Affected Product Manta camera series
PCN Title Manta type B housing material change
PCN No. 2015-03-02 **PCN Issue date** 2015-August-25
Contact <mailto:pcn@alliedvision.com>

All Manta type B cameras with housing (G-223 / 235 / 282 / 283 / 419 / 505 / 609 / 917).

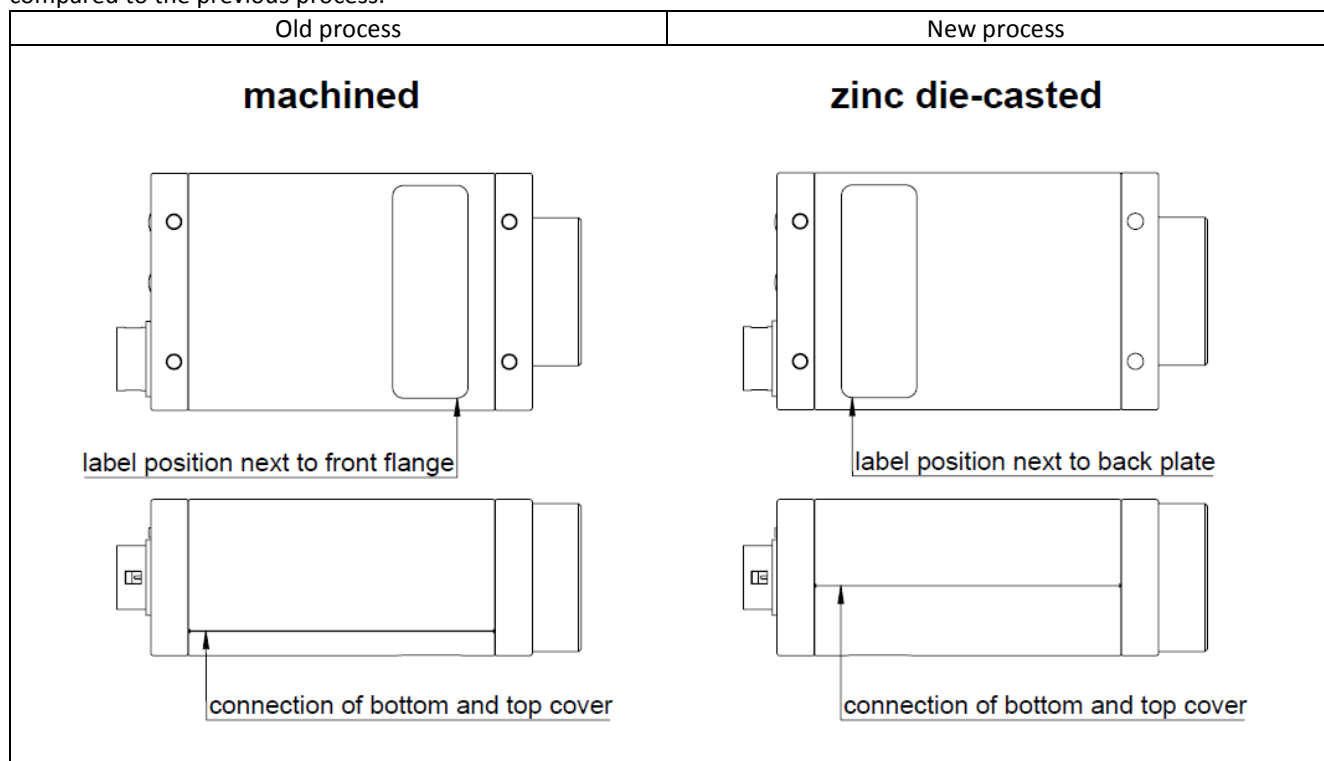
In order to use the same production processes, the Manta type B models will receive a new housing material (aluminum → zinc), as already used in the Manta Type A models. By using the material zinc with its different properties, e.g. the overall weight of the camera is increased by approximately 50g.

The conjunction of the two cover shells will be in a different position, as well as the position of the serial number label compared to the previous process.

No change in outer dimensions, surface and function.
